BUILDING COMPLETION REPORT.

Undersigned begs to report that the construction of add. tall:
on plot No. 875 (Mar 343) Sheet J. 23, Jamshed Quarter owned by
Mr. Keoharji Talje
has been completed according to plans approved by the Municipal Corporation.
Orders are requested to file correspondence.

Subject:— Completion plan and completion certi-
ficate, for the Bungalow on plot No.
D/5.(New.343) J.M.3. Karachi.

COMPLETION FOR
PROPOSED ADDITIONS & ALTERATIONS TO BUNGALOW ON PLOT No D/5 SHEET J.M.3.
FOR
THE COSMOPOLITAN CO-OPERATIVE HOUSING SOCIETY LIMITED.
SCALE 8 FT TO AN INCH

FIRST FLOOR PLAN.

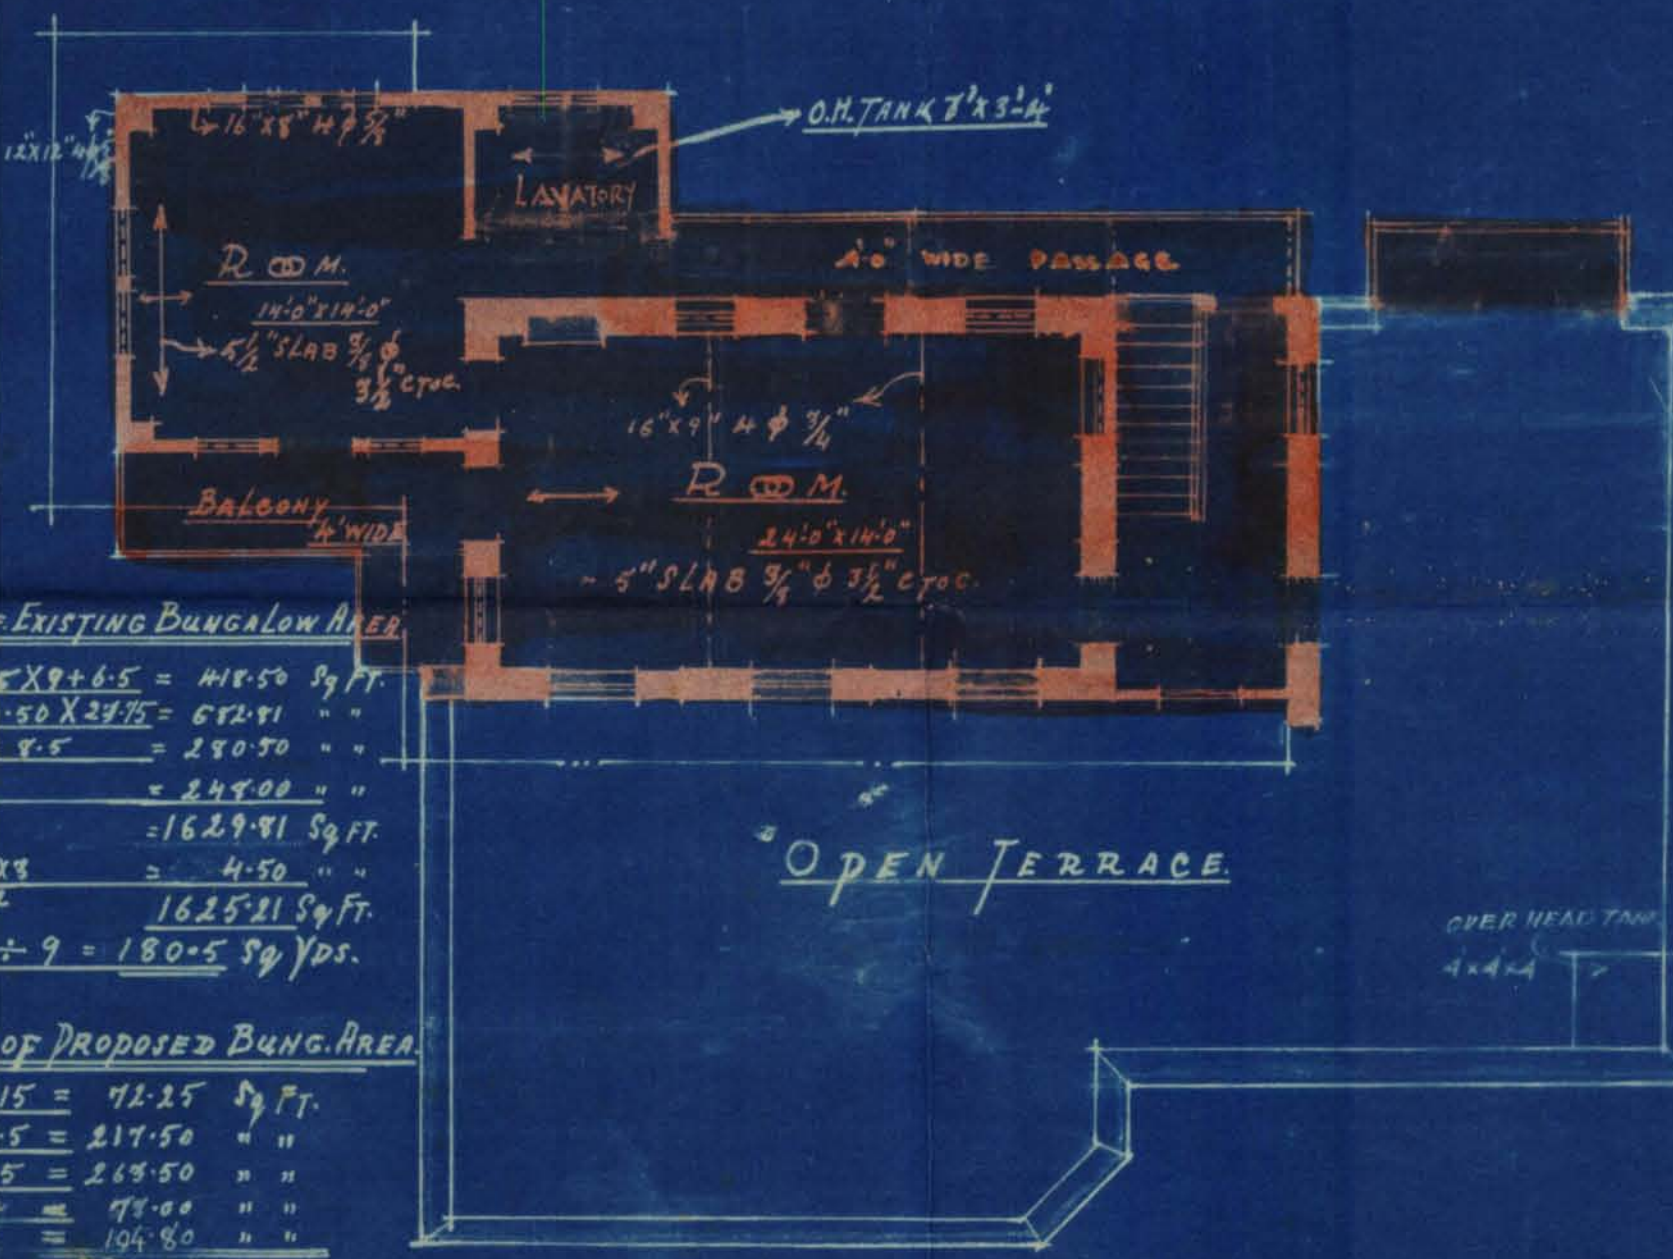
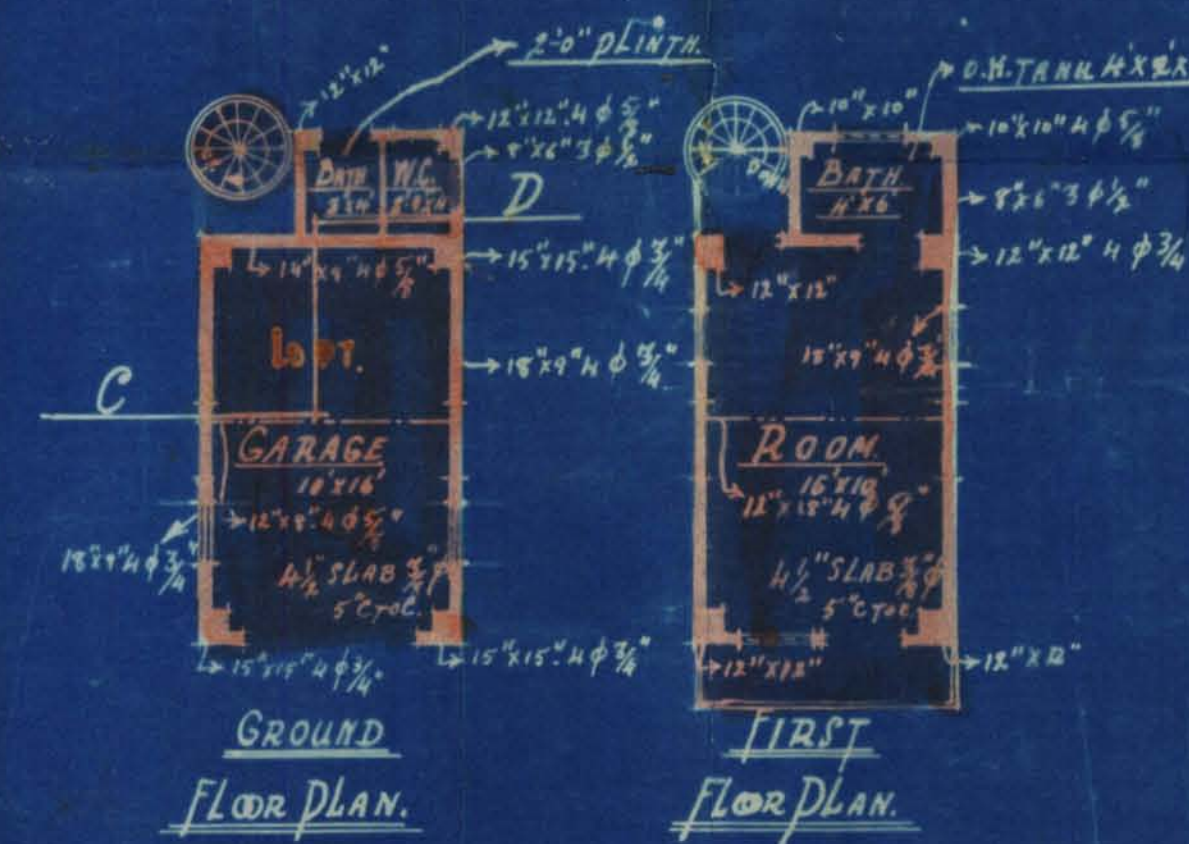
With reference to above, I have to request you to please comply with the objections of this office communicated to your architect on your behalf in letter No.L.O.P.276/39, dated 12th September 1939 and get the amended plan approved within seven days on receipt hereof, failing which, I regret, I shall be compelled to file prosecution against you, for building contrary to approved plan.

With reference to your application dated 16th August 1939,
with a plan for the proposed buildings/additions and alterations on plot
No. D/5 Survey Sheet No. J.M.3, Jamshed & Quarter,
I have to request you to comply with the following requirements—

(1) In the site plan measurements of the various rectangles
to be put down for the purpose of verifying the built up
area, and arrangements for joint measurements to be made.

(1) In the site plan measurements of the various rectangles to be put down for the purpose of verifying the built up area

With reference to your building on plot No. D/5 sheet
No. Jm 3, Jamshed, Quarter, I have to inform you that the
building as is being erected, or re-erected, differs from the approved
plan. You are therefore requested to make the building in
conformity with the approved plan on receipt hereof, failing which,
action will be taken under the Act which please note.

Built-up area checked along with the
architect (vide my report of 2/2 in this file).
No other objection -

*checked the built-up area & found it
correct.*
with architect.
3/11 *3/11*
